Comments on HIT calculation tool and HIT-WAD Diagram

The 14th IWG-DPPS
16-17 November 2021

JAPAN AUTOMOBILE STANDARDS INTERNATIONALIZATION CENTER

HIT-WAD diagram

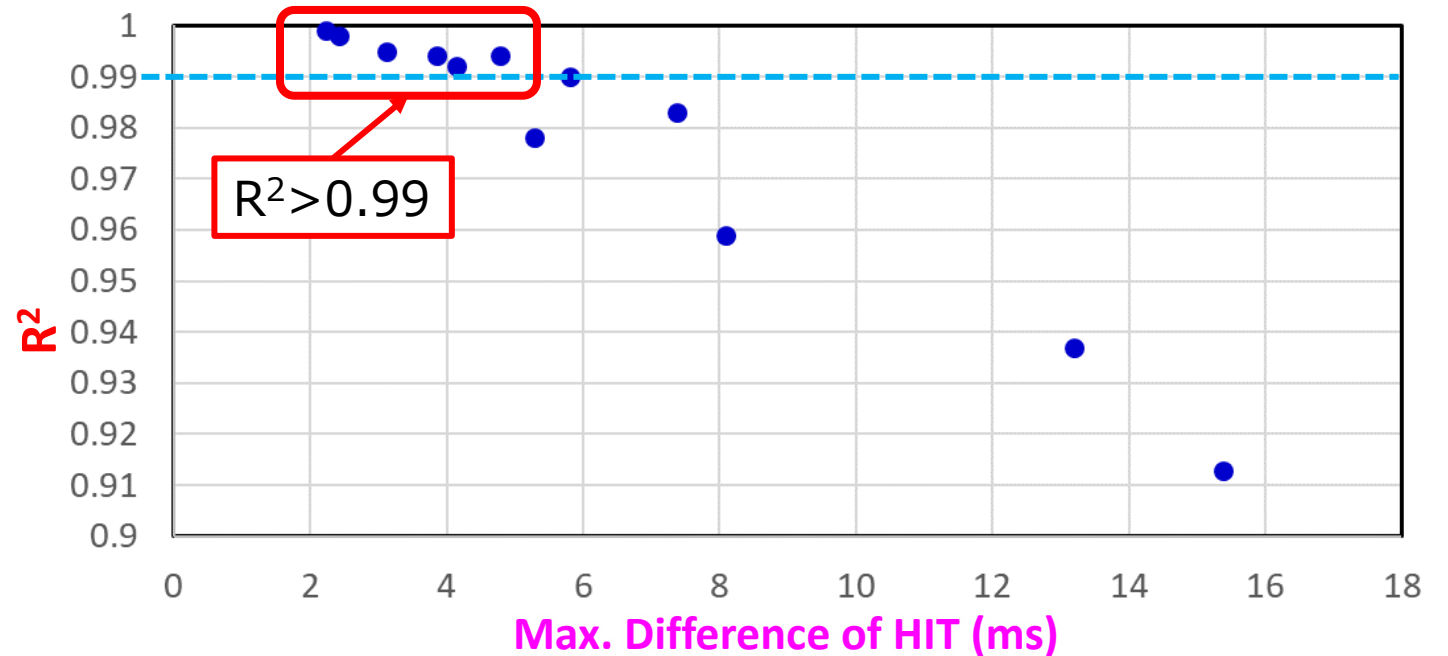
Analysis the data in IWG-DPPS 5th Intermediate web meeting presented from JASIC

- **Background:** Chair of IWG proposed that linear regression line should be used in case $R^2 > 0.99$ otherwise use Dot-to-Dot
- **Question:** Is the regression line regarded as same one as Dot-to-Dot in case $R^2 > 0.99$?

Relationship bet. R^2 and Max. Difference of HIT

- **Maximum difference of HIT is smaller than 5ms**
- **Japan agrees with the proposal from chair of IWG for drawing method for HIT-WAD diagram**
